Title INTERMITTENT DATA ERRORS					Tech Tip Number	
All	Processor Applicability				Author R. Woodson	Rev A
		8I	8L		Approval	Date 9-30-74
					Cross Reference

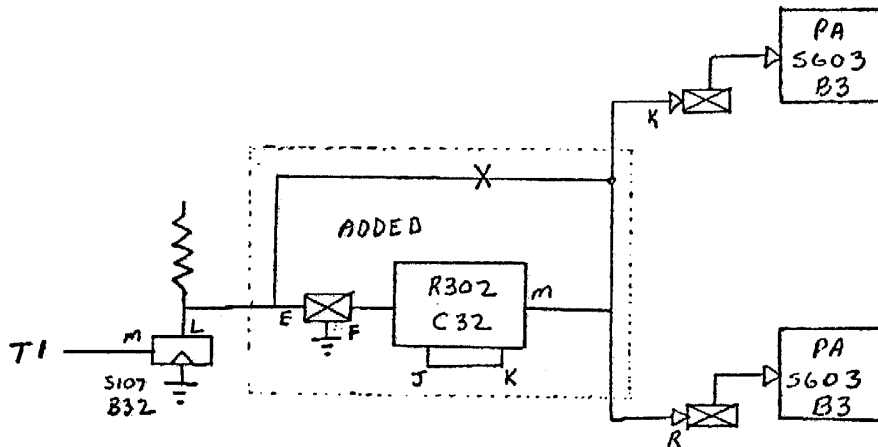
SYMPTOMS: When running DEC-X8 or any other program that causes back to back breaks of 3 cycle and single cycle devices, data errors occur on single cycle device.

SOLUTION: Modify DM01 as shown below.

To adjust R302 for best operation pin M of the R302 should be initially set to rise to ground level at the leading edge of TS3 in the processor. Then a pattern of all ones should be written on a data break device (preferably a disk for scoping) to be read back during adjustment. To adjust get computer in loop reading back all ones pattern written earlier. While syncing on break (1) look at data out of an adder and MB load. MB load, the first one on sweep, should occur during the time a one (low) is coming out of the adder. The R302 should now be adjusted until the leading edge of MB load falls approx. 50 ns before the trailing edge of the one.

Routines for writing and reading all ones should be available in the devices diagnostics.
